Access Compliance Report

Public Rights-of-Way

(Curb Ramps)

Intersection ID: 9491	Main Street: JUDSON_AV	Cross Street: ROZZELLES_FERRY_RD	Location: SE
ADA ID: E7171E80B113	Ramp Type: Perp	Initial Pass/Fail: Fail	Overall Compliance: No
Severity Score: 26.25			
Codes/Mitigation Info/Possible Solution		Field Measurements/Component Compliance

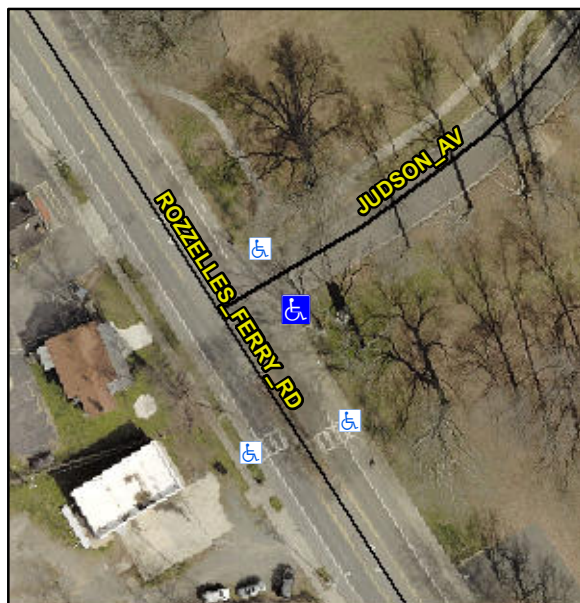
Not Found, R304.2.2, R304.5.3

Compliance	Description	Data	Compliance	Description	Data
N/A	Ramp Length (in)	73.5	No	Ramp Slope (%)	12.6
Yes	Ramp Width (in)	48.0	No	Ramp XSlope (%)	2.1
N/A	Flare Type LT	N/A	N/A	Flare Type RT	N/A
N/A	Flare Slope LT (%)	N/A	N/A	Flare Slope RT (%)	N/A
N/A	Flare Traversable LT?	N/A	N/A	Flare Traversable RT?	N/A
N/A	Landing Length (in)	N/A	N/A	DWS Provided?	N/A
N/A	Landing Width (in)	N/A	N/A	DWS Contrast?	N/A
N/A	Landing Slope (%)	N/A	N/A	DWS Length (in)	N/A
N/A	Landing X Slope (%)	N/A	N/A	DWS Full Width?	N/A
N/A	Landing Curb? (Y/N)	N/A	N/A	DWS Offset (in)	N/A
N/A	Shared Landing?	N/A			
N/A	Gutter Ponding?	Yes	N/A	Gutter Slope (%)	N/A
N/A	Gutter Lip Ht (in)	N/A	N/A	Gutter X Slope (%)	N/A
N/A	Painted X Walk1?	No	N/A	Painted X Walk2?	N/A
	X Walk 1 Direction	To NW		X Walk 2 Direction	N/A
N/A	X Walk 1 Width (in)	N/A	N/A	X Walk 2 Width (in)	N/A
	X Walk 1 Slope (%)	4.4		X Walk 2 Slope (%)	N/A
	X Walk 1 X Slope (%)	0.7		X Walk 2 X Slope (%)	N/A

Remove & Replace Entire Ramp.
